ECN/PCN No.: R0120

| For Manufacturer | | | |
|---|---|--|--|
| Product Description: GPS/GLONASS – Active Patch Antenna | Abracon Part Number / Part Series: APKD1507G2 | <input type="checkbox"/> Documentation only <input checked="" type="checkbox"/> ECN <input type="checkbox"/> EOL | <input type="checkbox"/> Series <input checked="" type="checkbox"/> Part Number |
| Affected Revision: I.R. | New Revision: A | Application: | <input type="checkbox"/> Safety <input checked="" type="checkbox"/> Non-Safety |

Prior to Change:

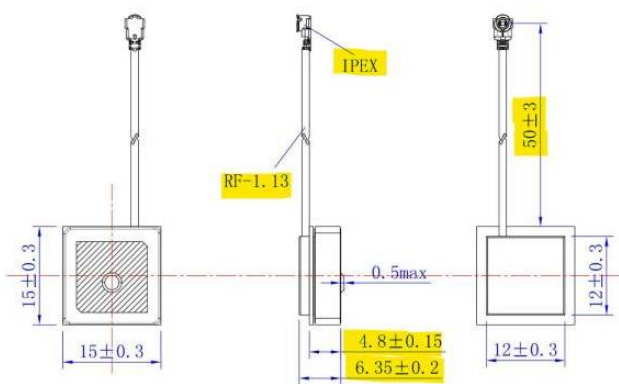
Cable length with large tolerance allowing for large variations.

Product Dimension

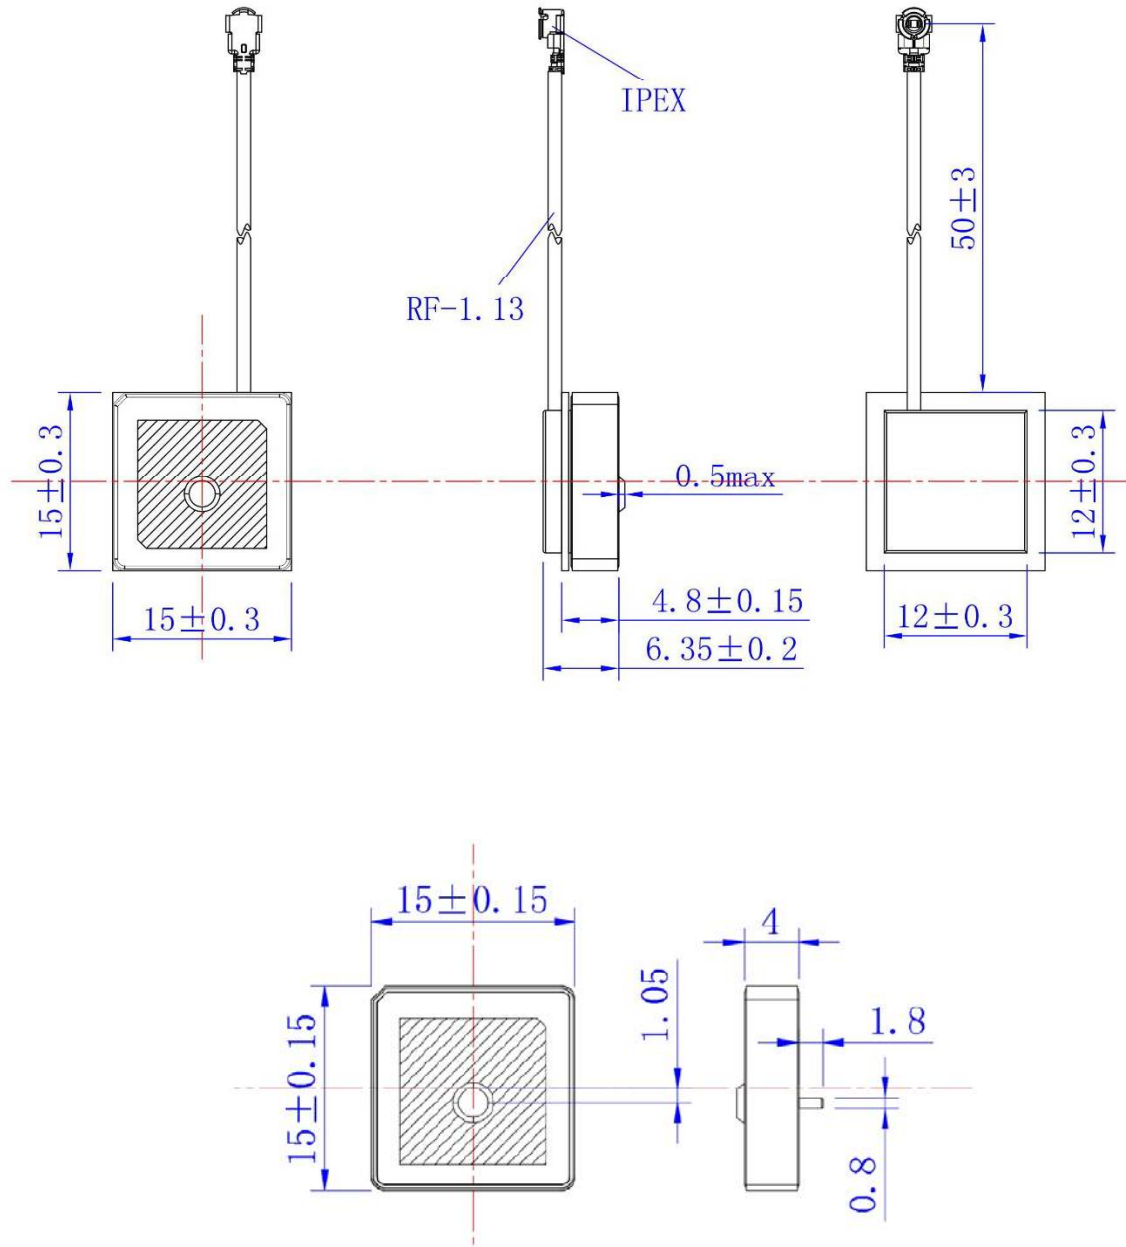
A more strictly defined cable length to having the cable extend the correct length from the PCB edge to the connector, as shown in the datasheet (see below), with a stricter tolerance of 3 instead of 5 mm. Please note that this could cause a ~5 mm longer nominal cable length compared to previous orders prior to this change.

| Change Plan | | |
|---|---|--|
| Change Declaration: Making the cable length more strictly defined. This could impact future orders with around 5 mm longer cable length than before. | | |
